SEWER PLAN AND PROFILE
MONROE CHATEAU
BRUNSWICK AVENUE
FROM MONROE ST. TO 260' S.W.Y.

APPROVED BY: *[Signature]* NO. S-170
DIRECTOR OF PUBLIC WORKS
DATE: 4-21-59 SHEET 1 OF 3 SHEETS

SEWER PLAN AND PROFILE
MONROE CHATEAU
COLORADO AVENUE
 FROM 100 FT. W. LY. OF TO MONROE ST.

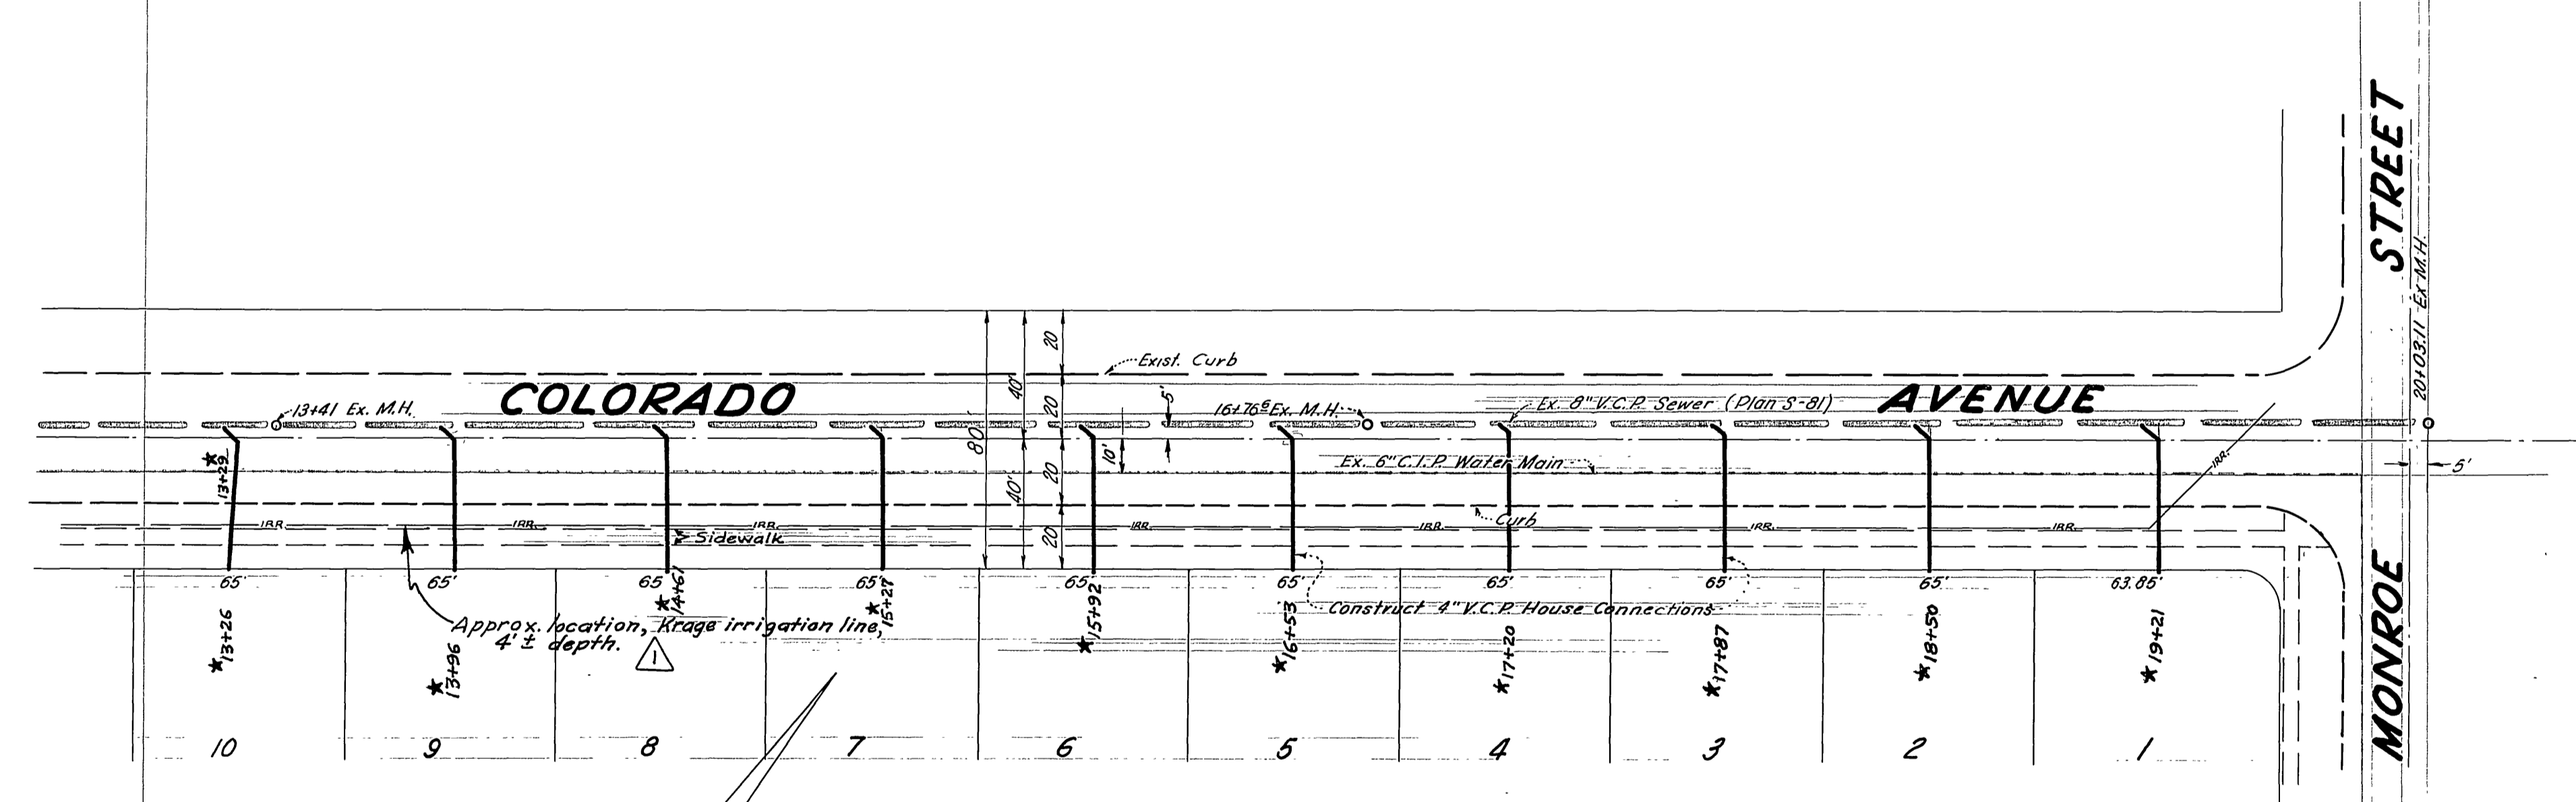
Mark	Date	Description
△	4-22-59	Krage irrigation line & sidewalk. H. Ball
★	7-16-59	"As Built" Laterals H. Ball
